T10/06-451 revision 1

Date: October 26, 2006

From: George Penokie (IBM)

Subject: SAS-2: SAM-4: Miscellaneous State Machine Fixes

Figure 1 — SL (link layer for SAS phys) state machines (part 1)

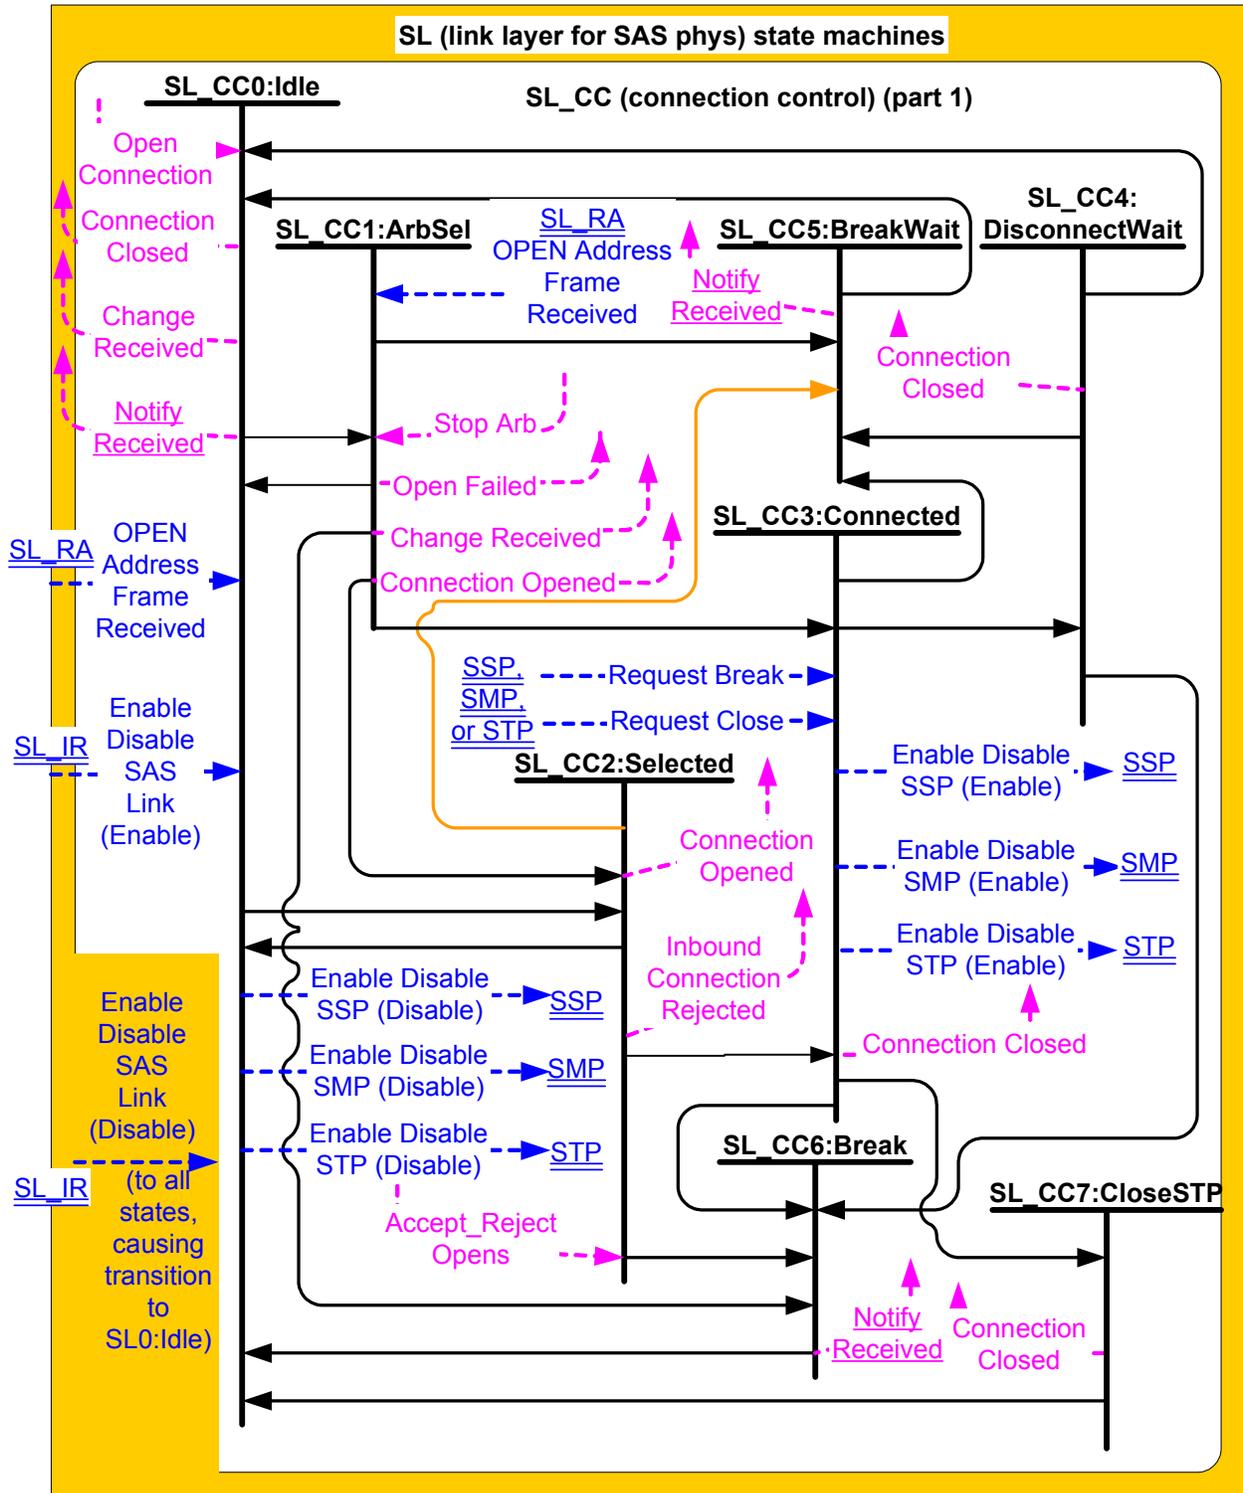
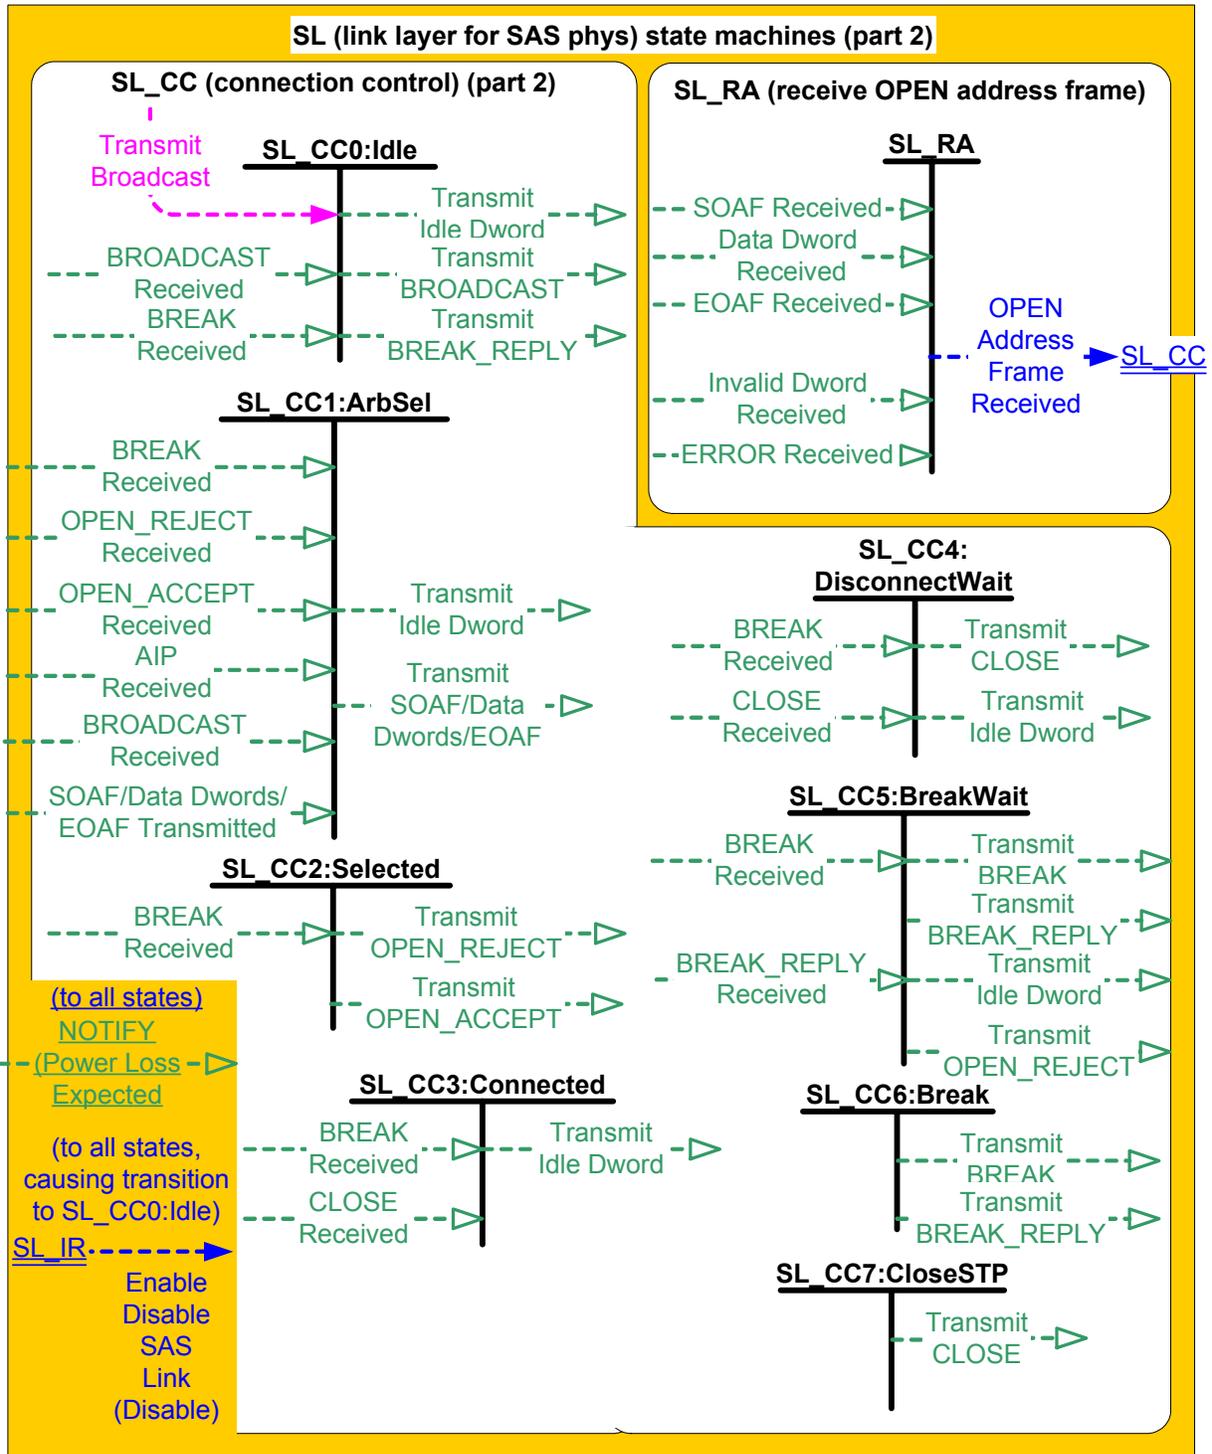
If a NOTIFY (Power Loss Expected) message is received then this state shall send a Notify Received (Power Loss Expected) confirmation to the port layer.

- a) a Stop Arb request is received and after sending an Open Failed (Port Layer Request) confirmation to the port layer; ~~or~~
- b) there is no response to the OPEN address frame before the Open Timeout timer expires and after sending an Open Failed (Open Timeout Occurred) confirmation to the port layer; or
- c) a NOTIFY (Power Loss Expected) message is received.

If a NOTIFY (Power Loss Expected) message was received this state shall include a Power Loss Expected argument.

Figure 3 — PL_OC (port layer overall control) state machine

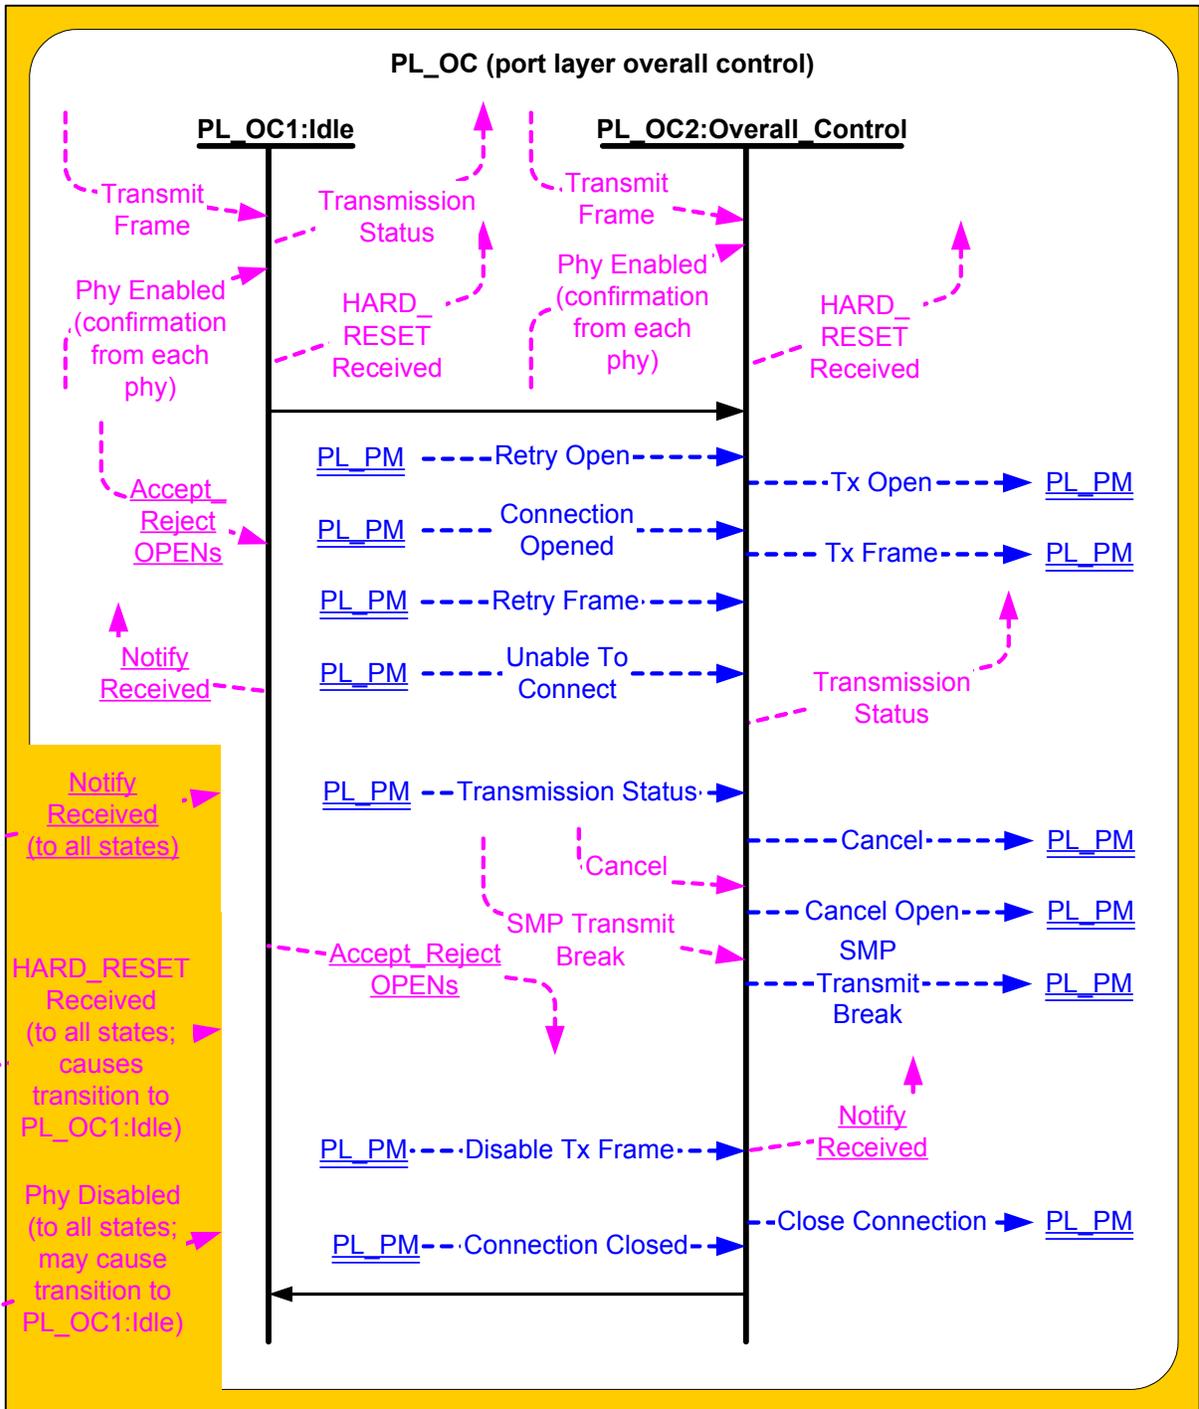
- a) discard all pending Tx Frame messages;
- b) delete all I_T Nexus Loss timers;
- c) send a Close Connection message to all the PL_PM state machines;
- d) send a Cancel Open message to all the PL_PM state machines; and
- e) send a Notify Received (Power Loss Expected) confirmation to the transport layer.

Figure 5 — Events and event notifications for SCSI target devices

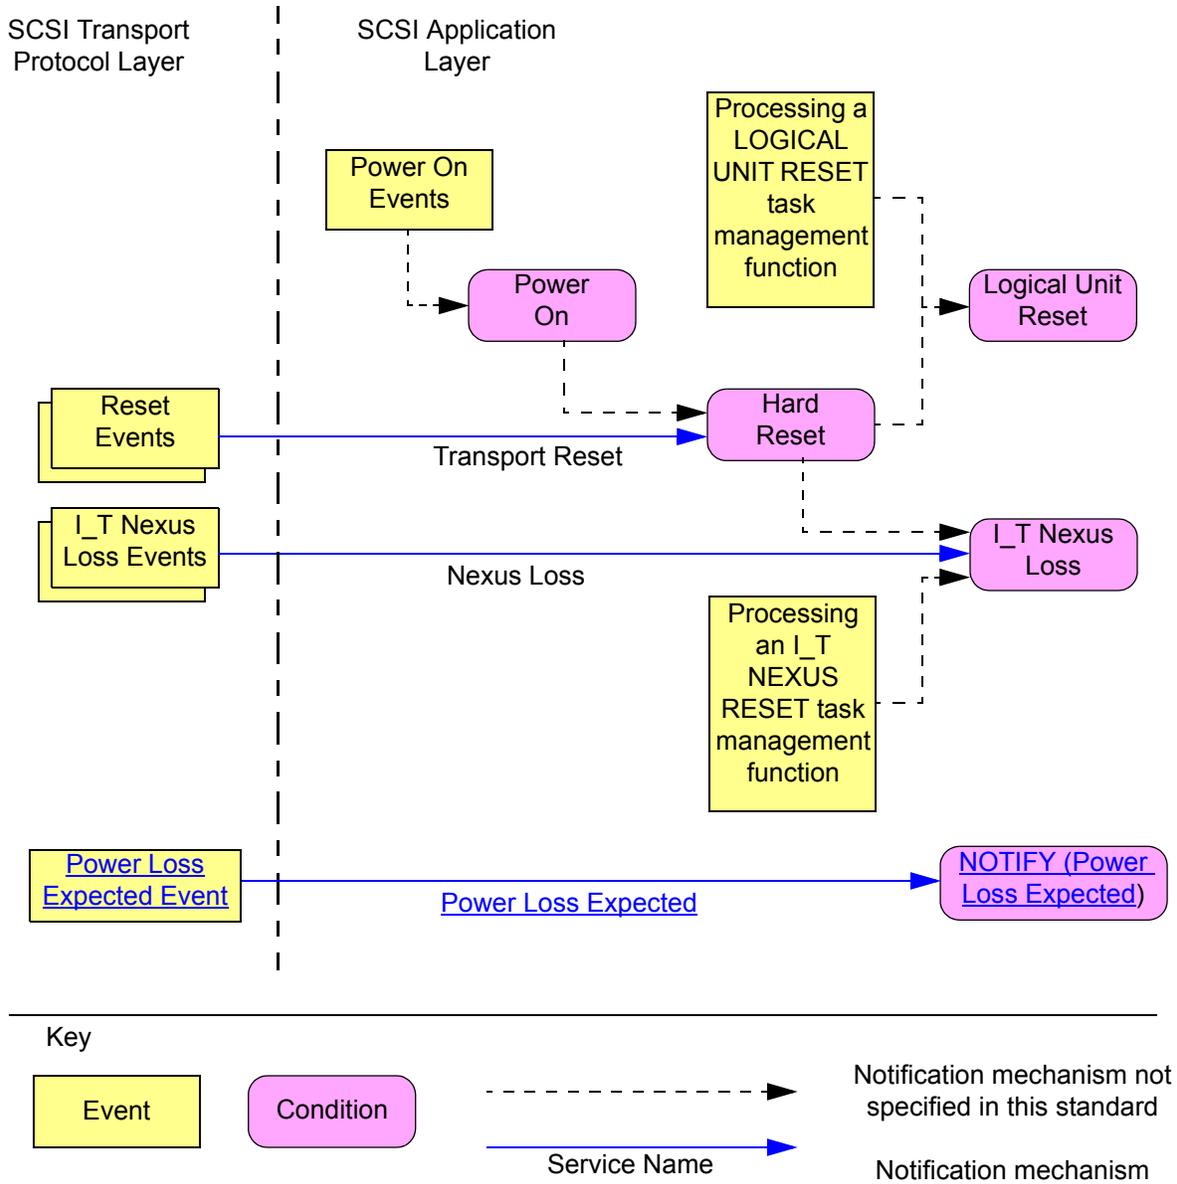
The events detected and event notification services usage depends on whether the SCSI device is a SCSI target device (see figure 5) or a SCSI initiator device (see figure 6). ~~SCSI target/initiator devices shall use the event notification services defined for both SCSI target devices and SCSI initiator devices.~~
